Re: 339 West Gorham Street: Oliv Madison

Attached is a minor amendment packet for the Oliv Madison Project. These changes address some program elements (expanded amenity), design refinements, and adding solar to the project. The packet illustrates the changes between the Original SIP document and the proposed amendments. The site plan review/building permit set elevations are also included for reference to show what was approved with the building permit.

UDC MINOR REVISIONS

ōliv MADISON 339 W GORHAM STREET

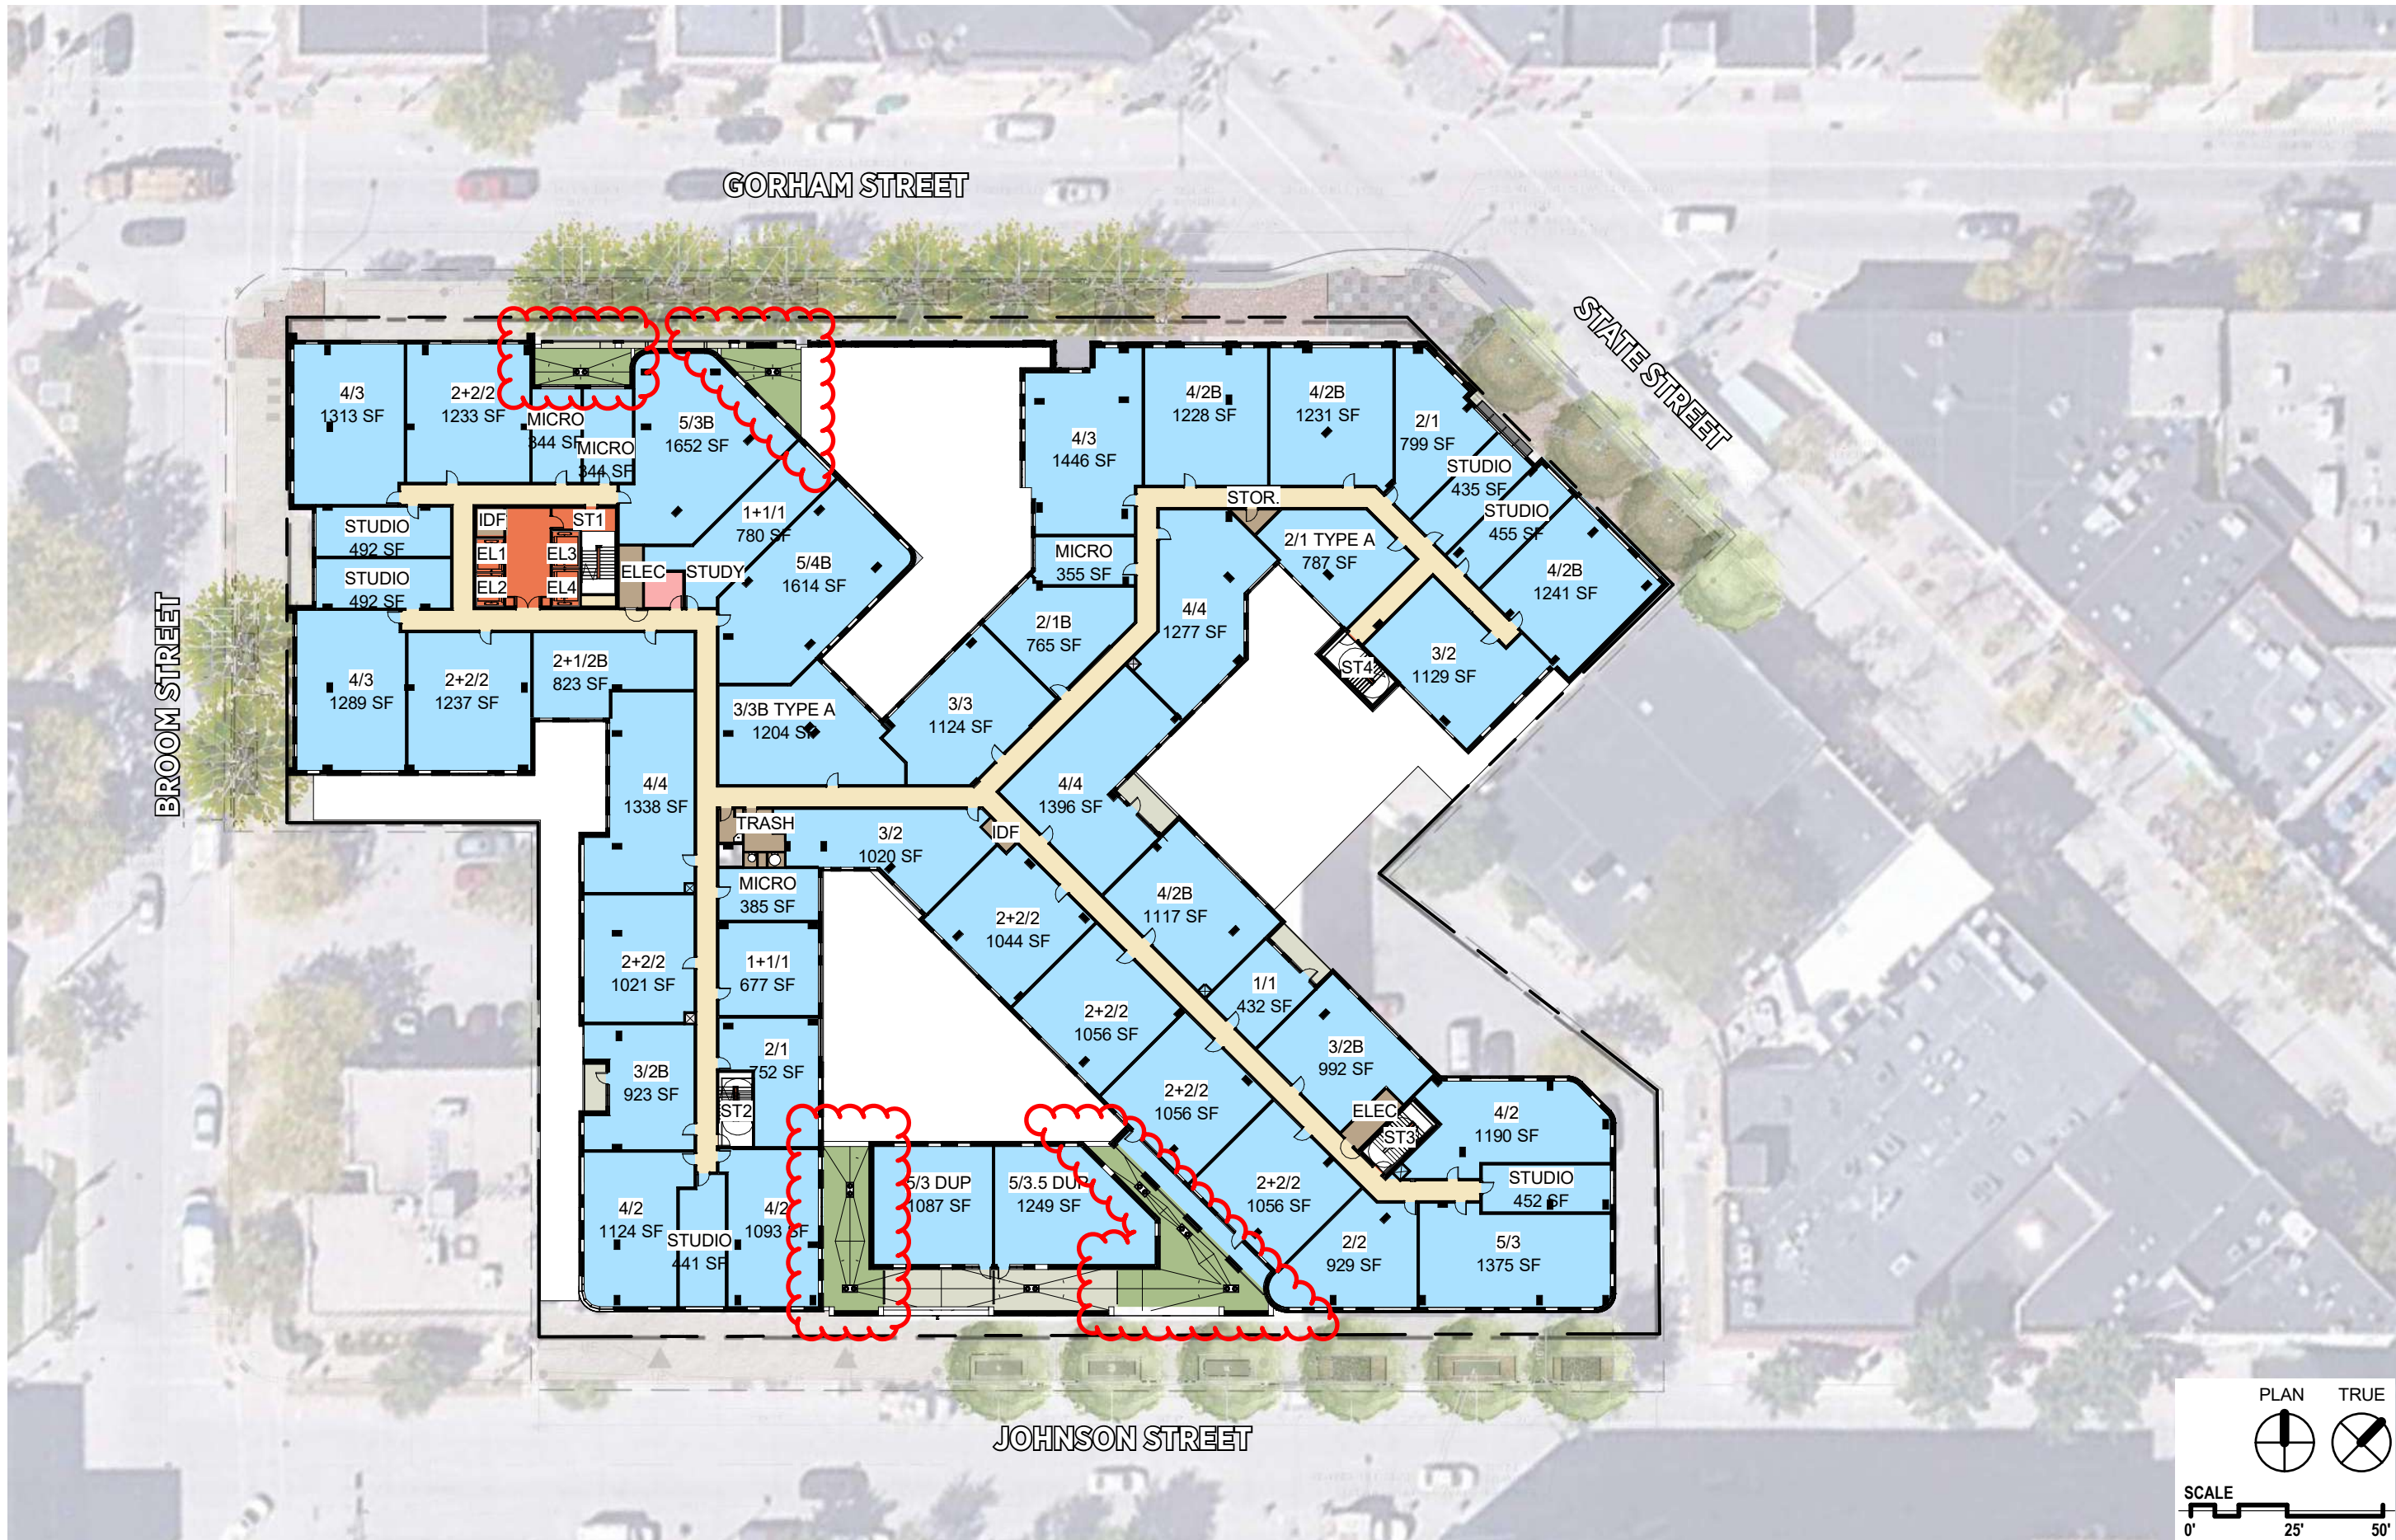
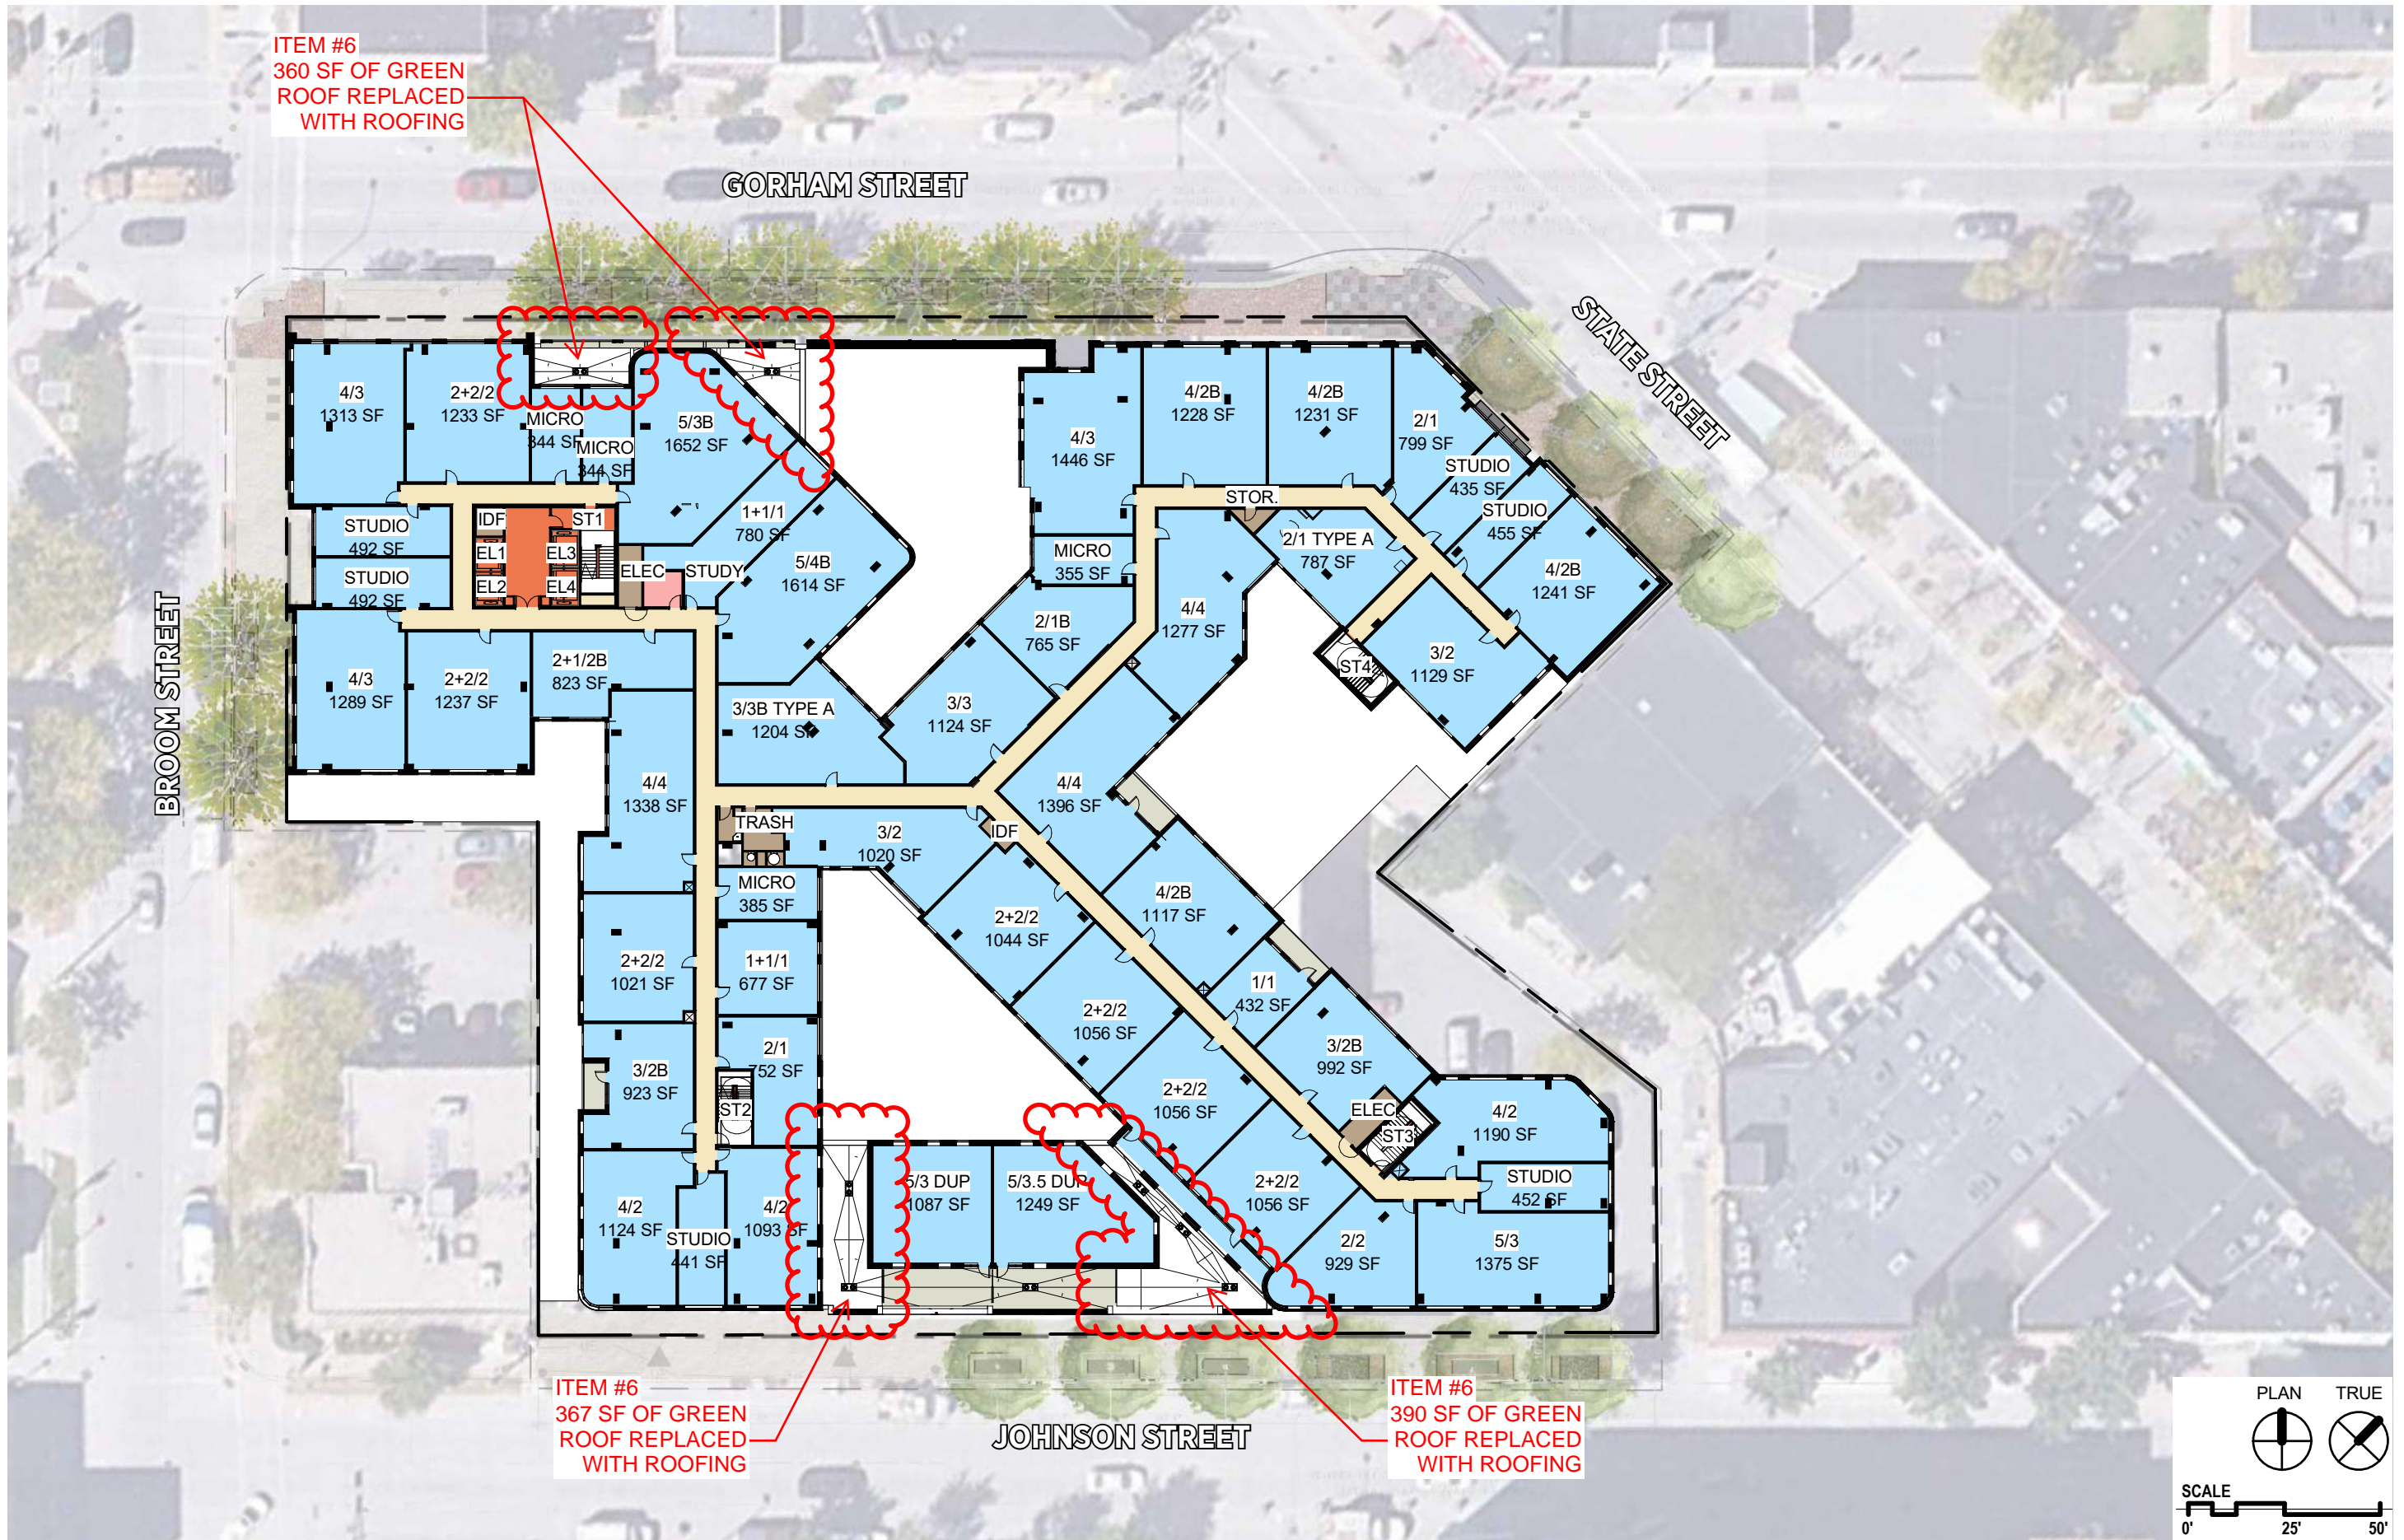
ITEM #5
FITNESS SPACE
EXPANSION

ITEM #5
PROPOSED: 5 BED/ 4 BATH
PREVIOUS: 4 BED /3 BATH

TOTAL BEDS: 1099
PREV. BEDS: 1102
